SN/Circ.218 18 July 2001

AMENDMENT TO THE EXISTING DEEP-WATER ROUTE NORTH-EAST OF GEDSER

EXTENSION OF THE DEEP-WATER ROUTE DW 17M INTO THE TRAFFIC SEPARATION SCHEME SOUTH OF GEDSER

AMENDED DEEP-WATER ROUTE NORTH-EAST OF GEDSER

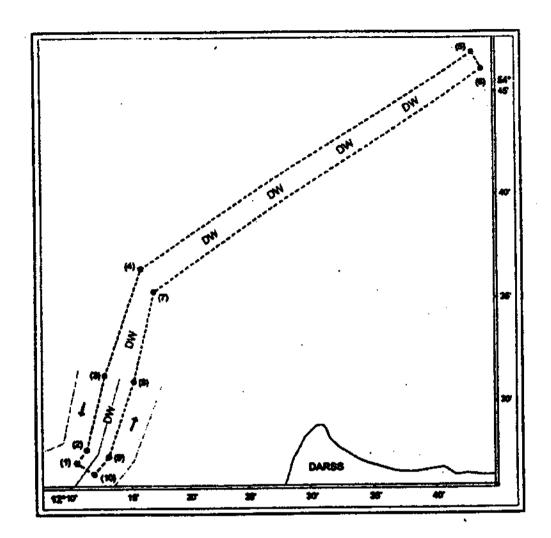
Existing	New	Geographical positions in WGS 84	
No.	No.		
	(1)	54°27'.10N 012°10'.50E	added
	(2)	54°27'.73N 012°11'.30E	added
(1)	(3)	54°31'.30N 012°12'.80 E	amended
(2)	(4)	54°36.46N 012°15.83E	
(3)	(5)	54°46.86N 012°43.23E	
(4)	(6)	54°46.06N 012°44'.03E	
(5)	(7)	54°35.36N 012°16.93E	
(6)	(8)	54°31'.00N 012°15.20E	amended
	(9)	54°27'.40N 012°13'.10E	added
	(10)	54°26.57 N 012°11'.90 E	added

A deep-water route with a minimum depth of water below mean sea level of 17 metres is bounded by a line connecting the following geographical positions:
